## CLEVELAND NATIONAL FOREST POWER LINE REPLACEMENT PROJECTS

### MINOR PROJECT REFINEMENT REQUEST FORM

<b>Date Submitted:</b>	02-10-20	<b>Request #:</b>	044
<b>Date Approval Required:</b>	03-23-20	<b>Landowner:</b>	Various
<b>APNs:</b>	XXX-XXX-XX, and XXX-XXX-XX		
<b>Refinement from (check all that apply):</b>			
<input type="checkbox"/> Mitigation Measure	<input type="checkbox"/> APM	<input checked="" type="checkbox"/> Project Description	<input checked="" type="checkbox"/> Drawing <input checked="" type="checkbox"/> Other
<b>Identify source (mitigation measure, project description, etc.):</b>			
<p>As described in the Final Environmental Impact Report/Environmental Impact Statement (EIR/EIS) for the Cleveland National Forest Power Line Replacement Projects (Project), removal of Transmission Line (TL) 626 from service (also referred to as TL626RFS) and the conversion of TL626 from 69 kilovolt (kV) to 12 kV are part of the Environmentally Superior Alternative and the Federal Preferred Alternative. As shown in Figure E-1: Environmentally Superior Alternative (CEQA) and Federal Preferred Alternative (NEPA) of the Final EIR/EIS, the 69 kV to 12 kV conversion on TL626 includes northe

Attachment B:  
Comparison Map  
TL626 Conversion South  
Map 7 of 40

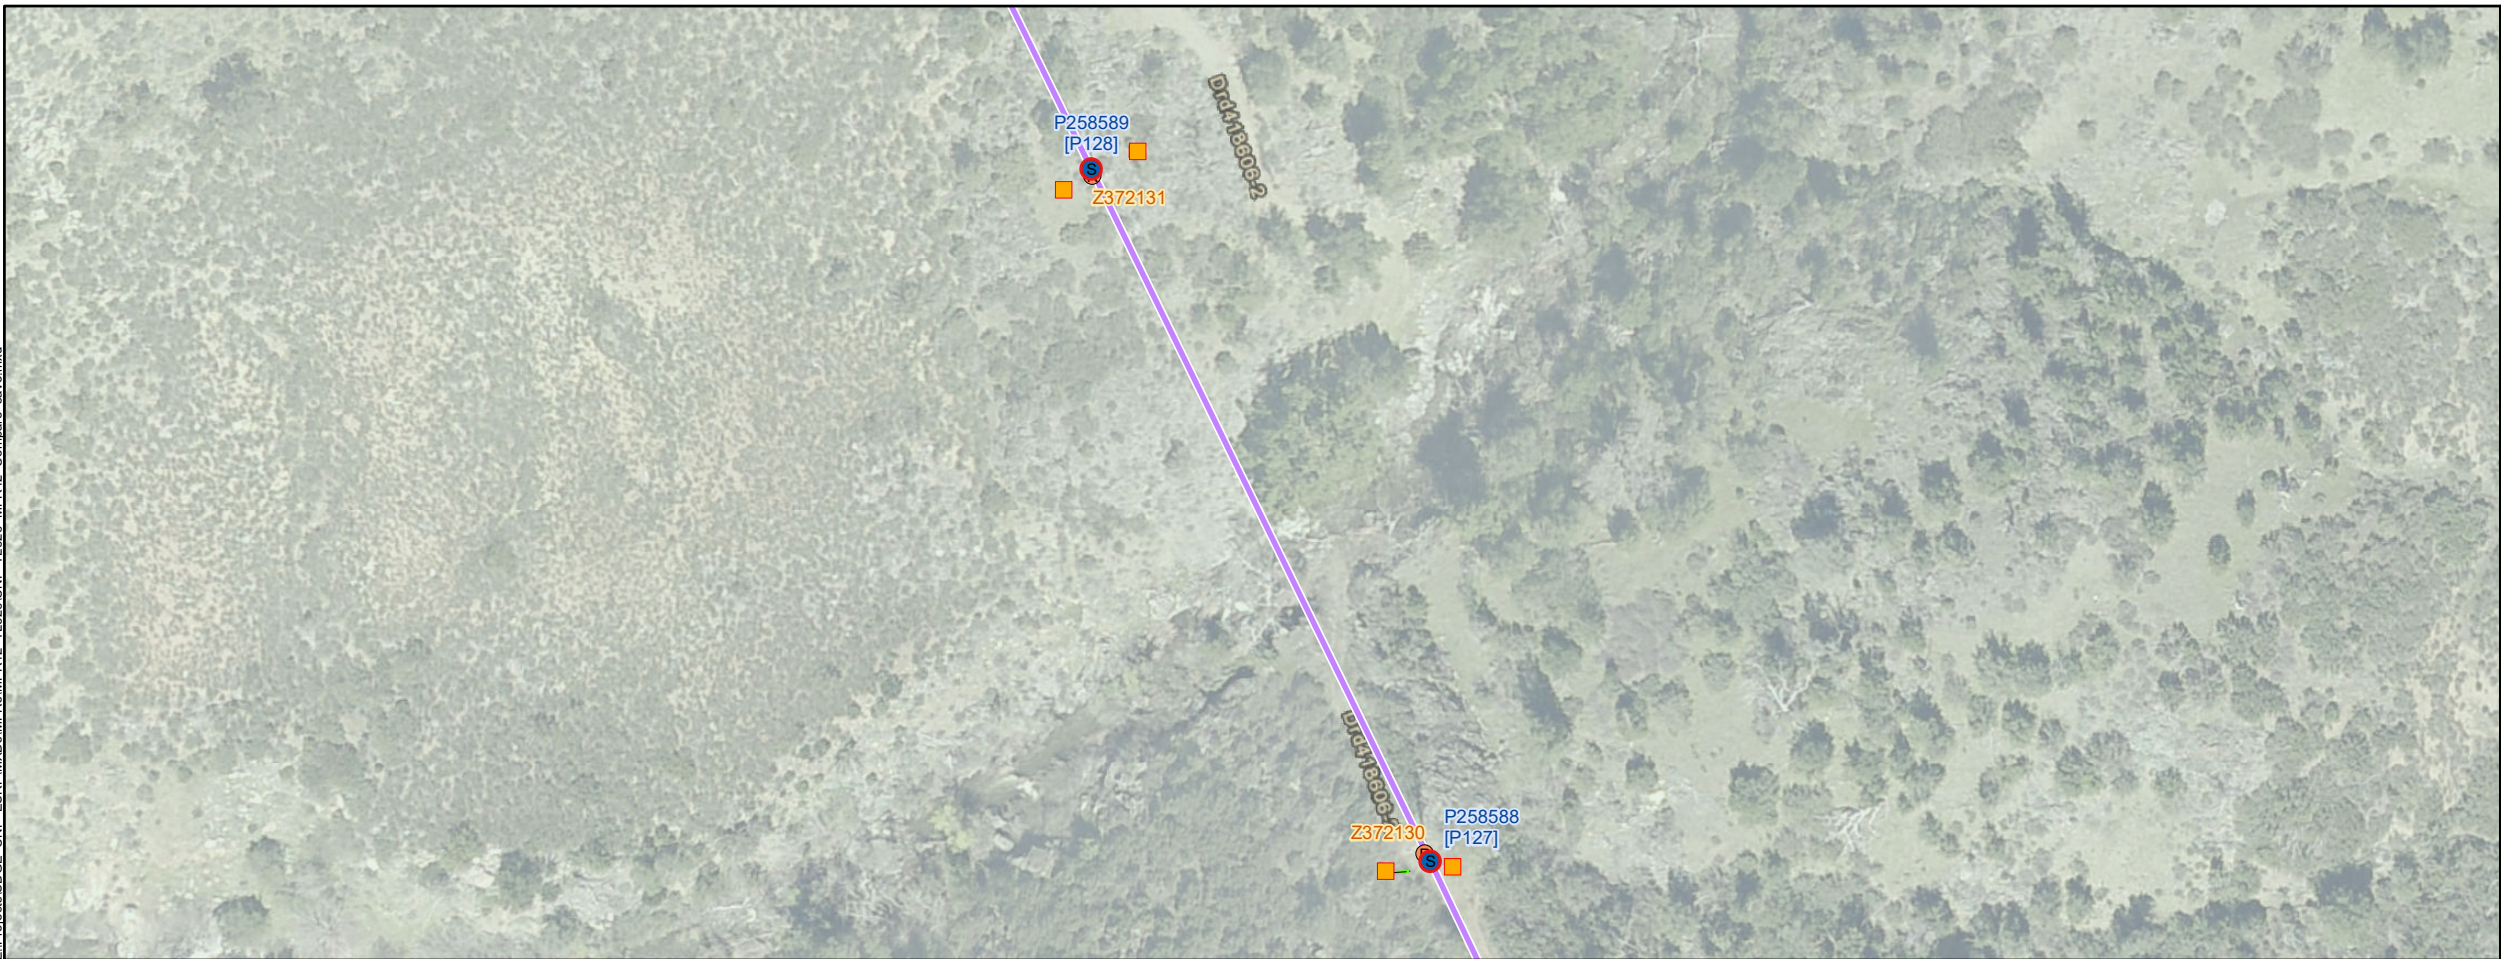
MPR #44

Wood-to-Steel Replacement 12 kV Only

Remove from Service Anchor

Anchor Work Area

Wood-to-Steel Replacement
